Reference: Engineering Services
301 Denim Dr.
Erwin, NC 28339
TE&D Project No.: 2101-020236

As requested, a representative of Tyndall Engineering & Design, PA (TE&D) was on-site to observe the following items:

Example of Dry Stacked Foundation Wall

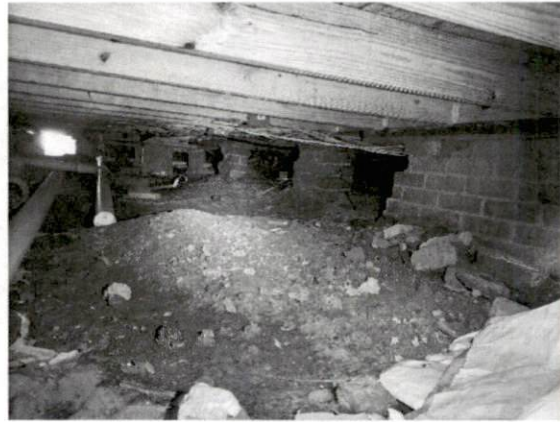
- 1) Based on our observations and analysis, the dry stacked foundation wall at the rear of the addition is not suitable. The foundation is to be constructed with an 8" masonry wall with a continuous 8" x 16" concrete footing.

Example of Existing Girder

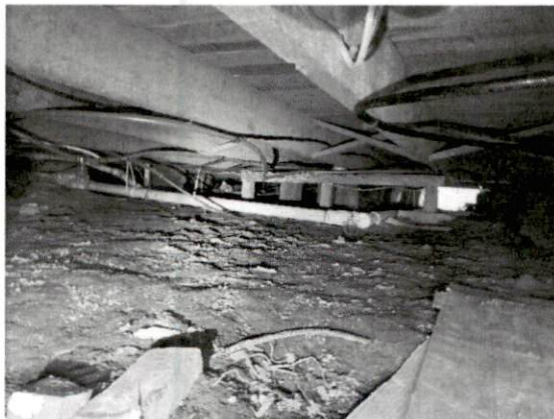
- b. The existing stem wall slab under the mid-section of the addition is suitable.
 - c. The existing girder running front to back between the existing house and addition is not suitable. We recommend a (3) 2 x 10 girder with 8" x 16" piers at 5'-0" o.c. Piers are to be supported by 24" x 24" x 8" footings. The girder is to extend from the right rear corner of the living room to the left rear bedroom corner adjacent to the back door. See attachment.
